FECON SERVICE BULLETIN

Document ID: SB-174

Equipment Model: RK5015 and RK6015 Mulchers

Component: Inline Check Valve (P/N: 182578)

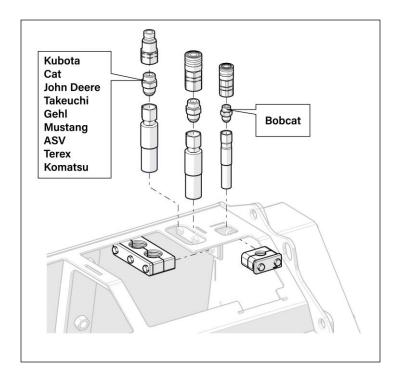
1. Replace the existing hose union in the main return hose with the new inline check valve (P/N 182578) as shown in illustration below:
